SUNDRY NOTICES AND REPORTS ON WELLS

OXY USA WTP Limited Partnership

OXY Jazz Federal 1

OXY USA WTP LP - Proposed
OXY Jazz Federal #1
API No. 30-015-30748

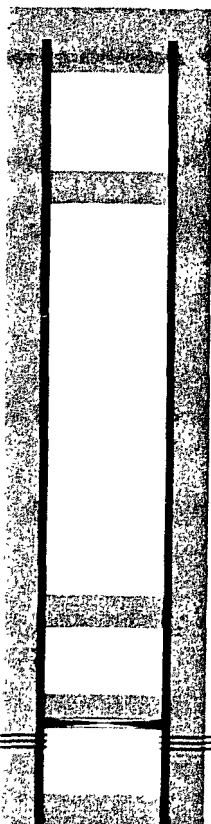
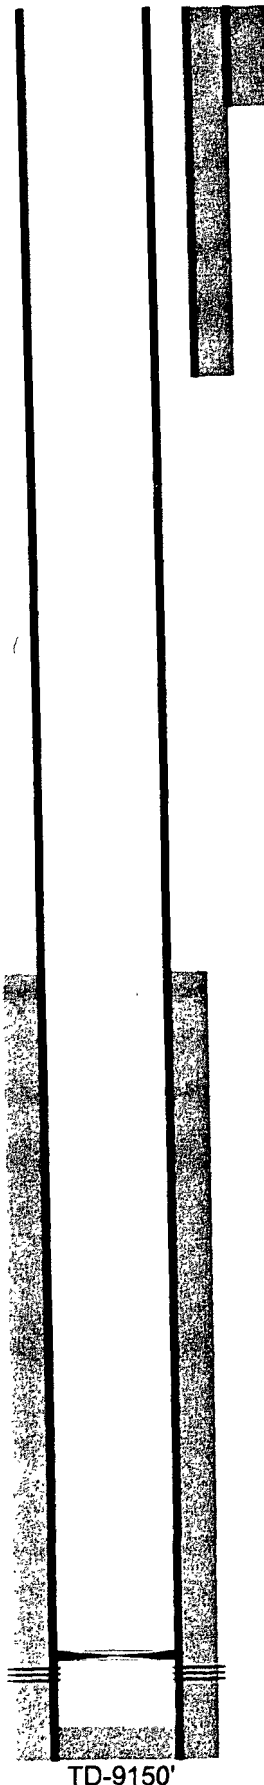
1. Approval is granted to P/A this well with the following modifications to the program:
2. Class H cement, will be used for all plugs below 8000'.
3. The surface plug must be circulated to the surface from 100 feet.

*** All plugs, including the surface plug, should leave at least 25 sacks of cement inside the casing and be at least 100 feet, plus an additional 10% for each 1000 feet of depth.**

Plugging procedures must conform to 43 CFR 3162.6.d and Onshore Order No. 2.III.G or NMOCD orders if they are more stringent.
